8. Well Name and No.  
RED HILLS NORTH UNIT 710

EOG PROPOSES TO PLUG AND ABANDON THIS WELL USING THE ATTACHED PROCEDURE, CURRENT AND PROPOSED WELLBORE SCHEMATICS ATTACHED.

\*\* BLM REVISED \*\* BLM REVISED \*\* BLM REVISED \*\* BLM REVISED \*\* BLM REVISED \*\*

RHNU #710 WIW P&A Procedure

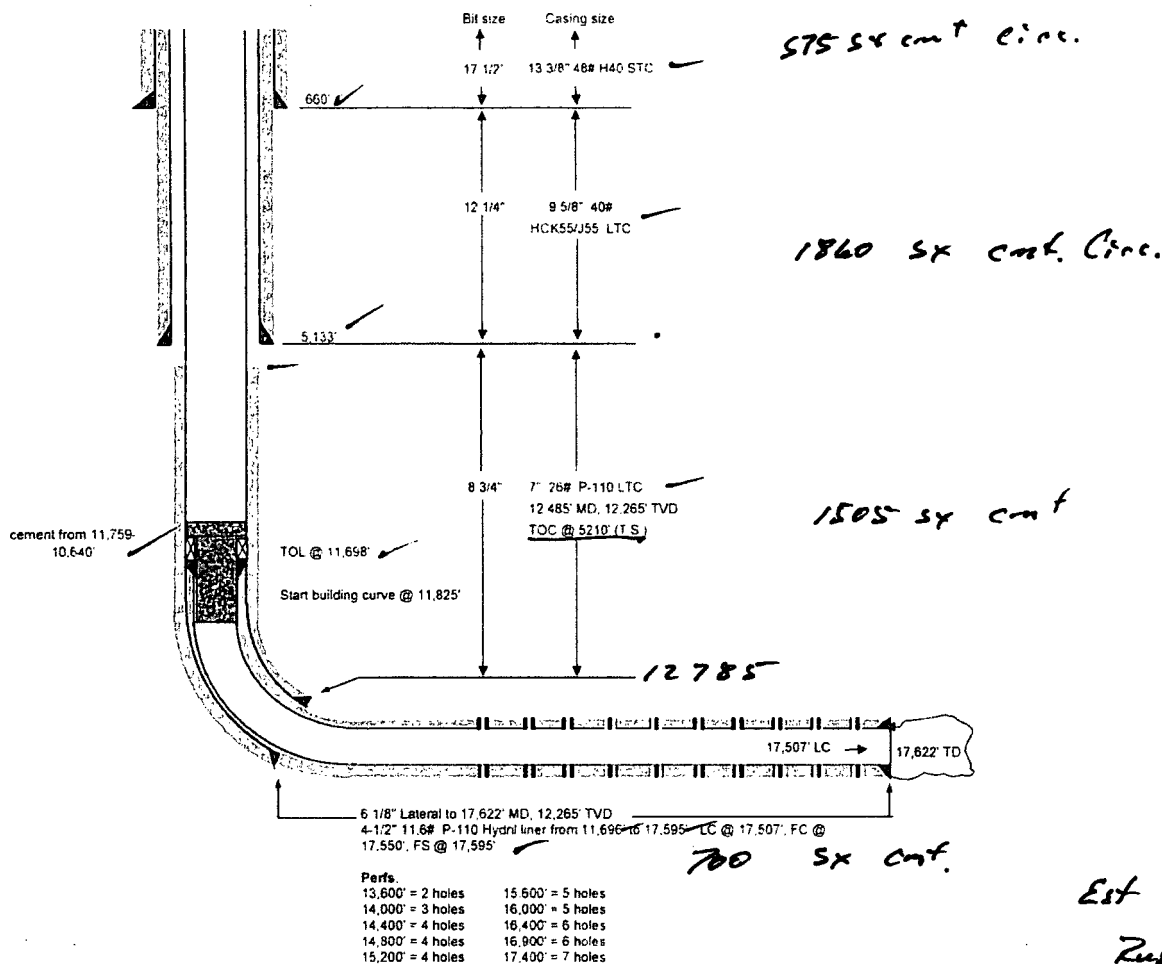
1. Well status is currently TA, with a cement plug from 11,759'-10,640'
2. Spot 45 sx class H @ 7840'-7640
- ~~X~~ 3. ~~Spot 45 sx class C @ 5183'-5033' WOC & tag (9-5/8" shoe)~~
- ~~X~~ 4. Perf and squeeze 45 sx class C @ 2233'-2093' *Spacer, WOC Tag*
5. Perf and squeeze 45 sx class C @ 710'-610' (WOC & tag, 13-3/8" shoe)
6. Perf and squeeze 85 sx class C @ 200-surface
7. Cut off wellhead and weld on dry hole marker

Tag PBD 10640<sup>th</sup>  
 Add plug across Top  
 BS. From 9305-9105.  
 45 sx min. class  
 "H"

RHNU NO. 710W

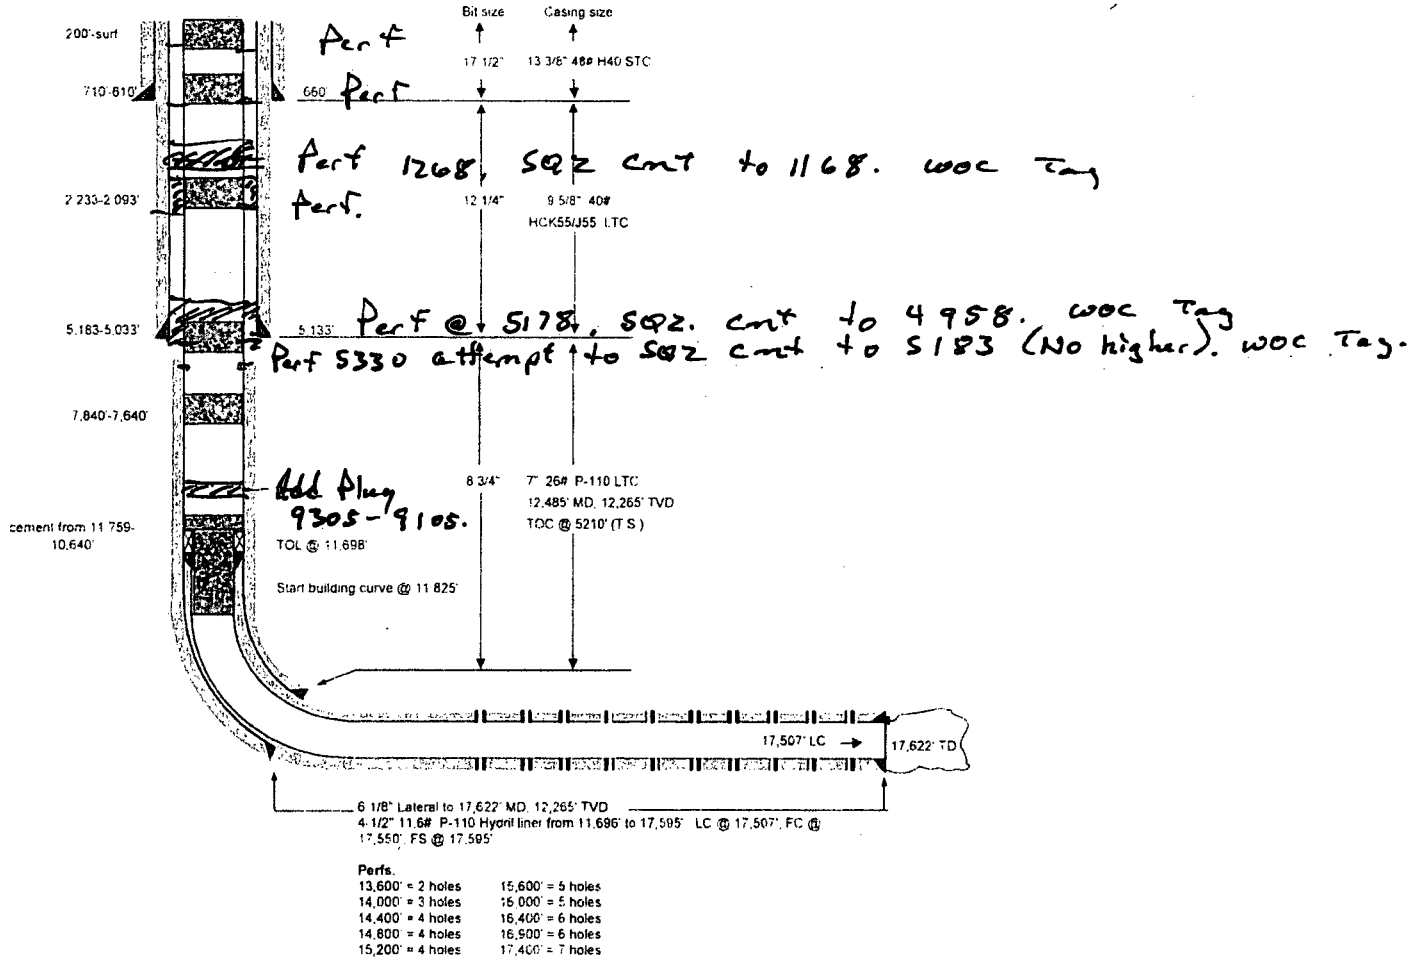
3. Perf @ 5330 attempt to SQZ Cmt. to 5183. (No higher). WOC Tag. (Top Delaware.). Perf @ ~~5183~~ 5178, SQZ cmt to 4958. WOC Tag. (9 5/8 shoe, Base Salt).

4. Add plug: Perf. @ 1268, SQZ Cmt to 1168. WOC Tag. (Top Salt).
